400 Longwater Avenue
NMA03 - Mark-up of changes compared to NMA 02

Project 400 Longwater Avenue, Green Park		
Drawing Title Alternative Scheme Site Plan		
Scale 1 : 500 @ A1	Drawn By RPP	Issued By RPP
Stage 3		
Project No. 15011	Drawing No. A_PL_020	Revision 00

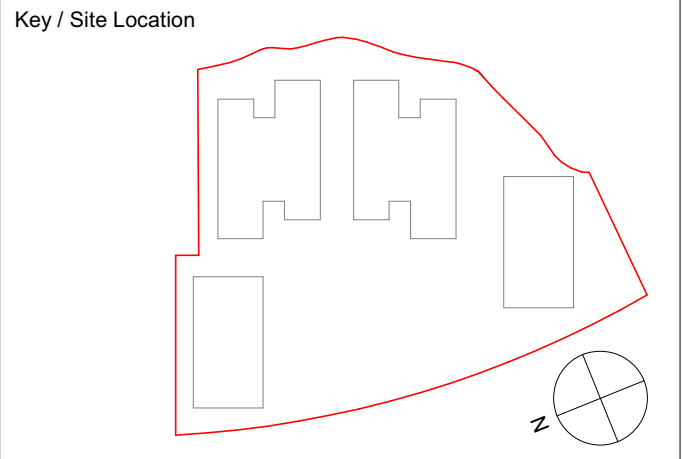
The car park structures have been amended to accommodate changing room and shower facilities, together with cycles and bin stores and the required plantrooms

The configuration of the car park at grade has been adjusted according to the new car park structures. The overall number of car park spaces is the same as the NMA 02.

The shape of the southern car park structure matches the one of the northern; its footprint has been reduced and its location is further away from the main building.
